-01 (X-ARM)

SECTION A-A
FOR A COMPLETE ISC STRUCTURAL TABLE LAYOUT, SEE LIGO D1102291
(BOTTOM VIEW: ETM TELE TUBE LIGO d1000072, NOT SHOWN)

ISO VIEW, FRONT RIGHT

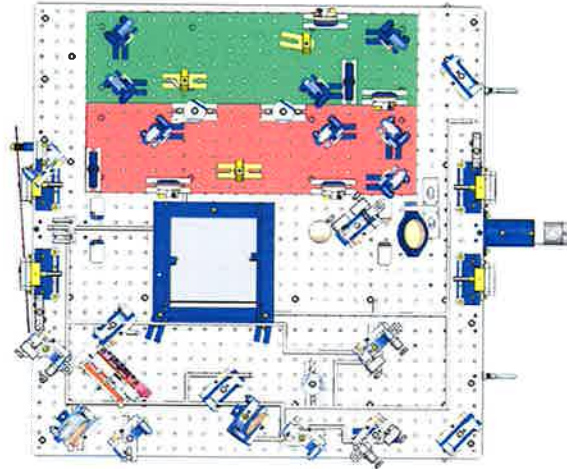
what will call "8 o'clock" clamp

what will call "4 o'clock" clamp

what will call "12 o'clock" clamp

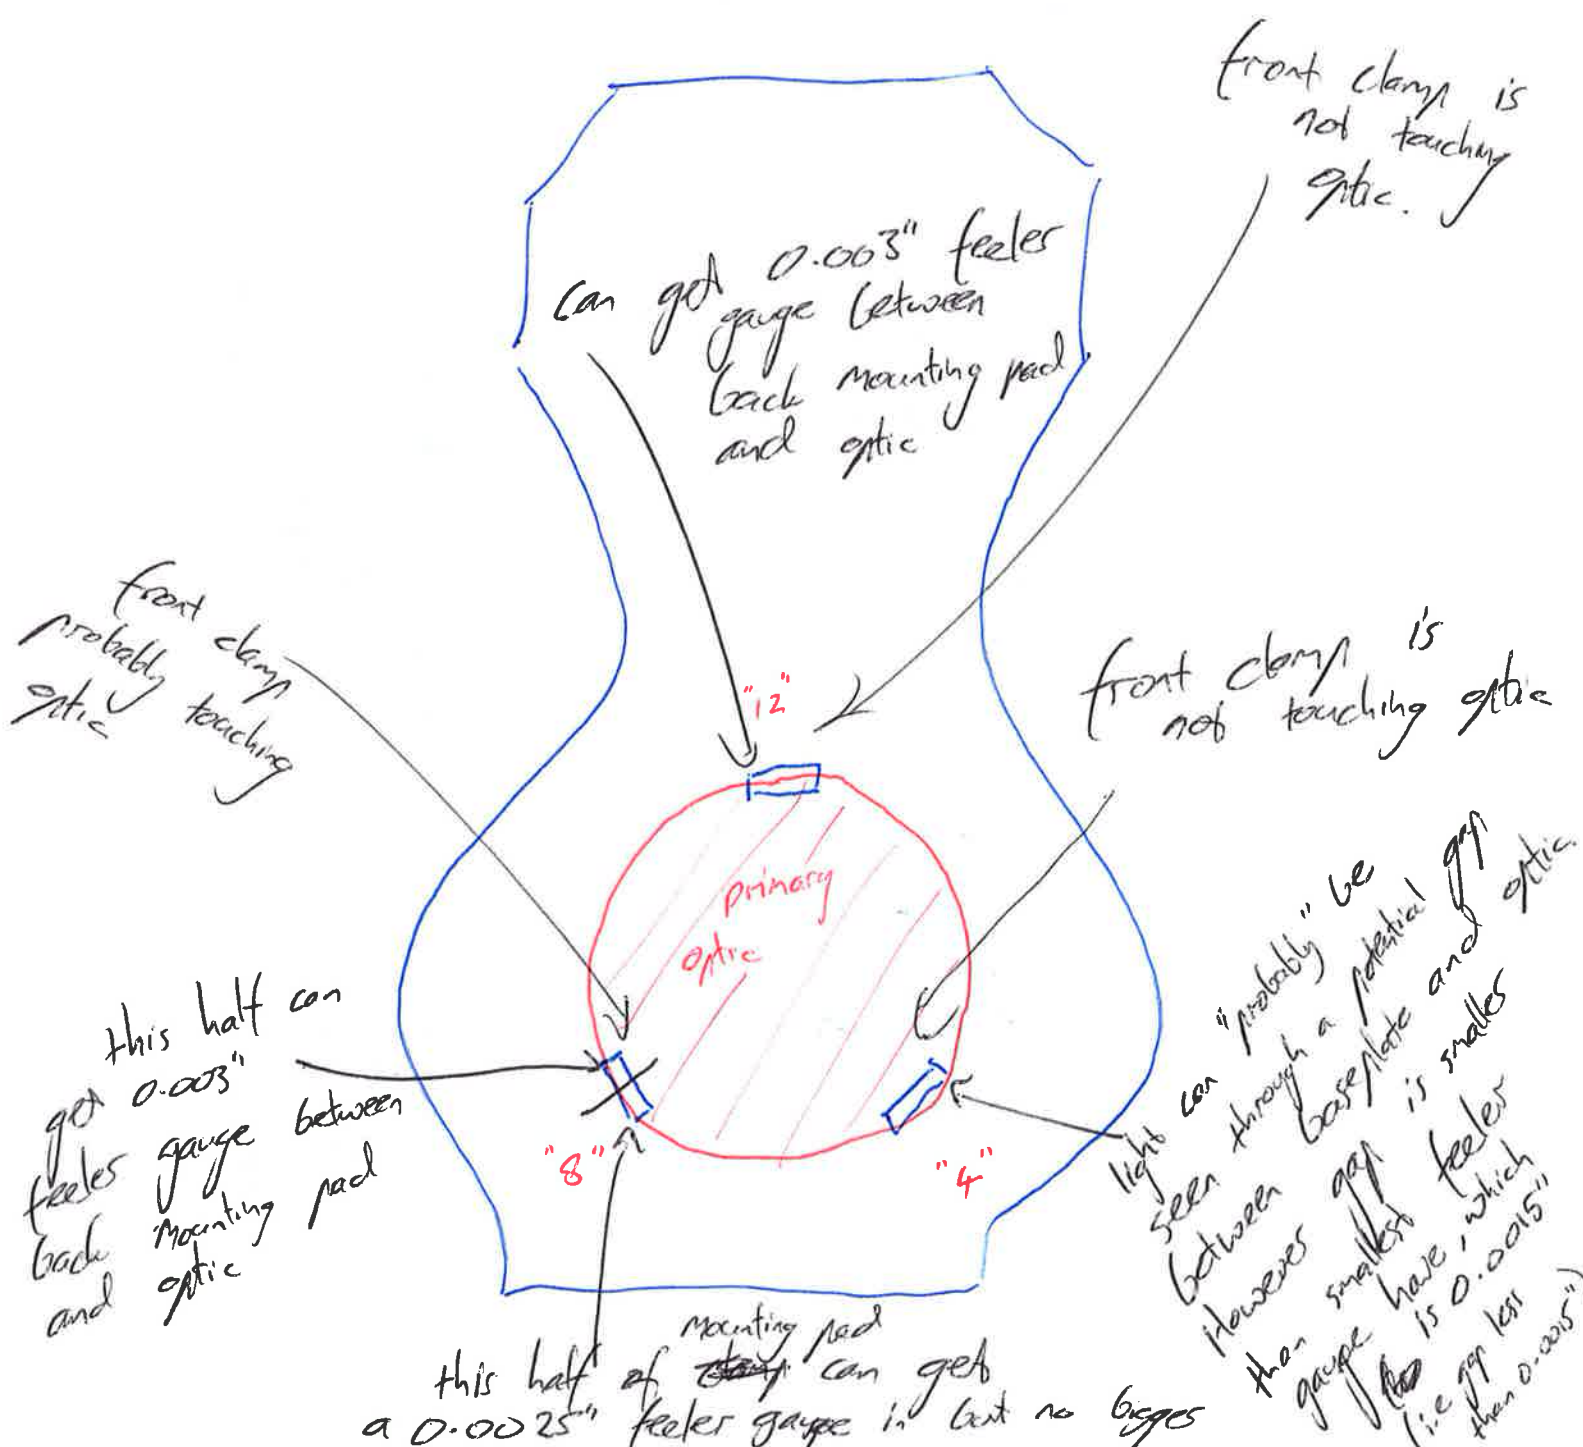
front clamp is not touching optic. ✓

can get 0.003" feeler gauge between back mounting pad and optic

front clamp probably touching optic

front clamp is not touching optic

this half can get 0.003" feeler gauge between back mounting pad and optic

light can "probably" be seen through a potential gap between base plate and optic however gap is smaller than smallest feeler gauge have, which is 0.0015" (i.e. gap less than 0.0015")

this half of ~~the~~ mounting pad can get a 0.0025" feeler gauge in but no bigger
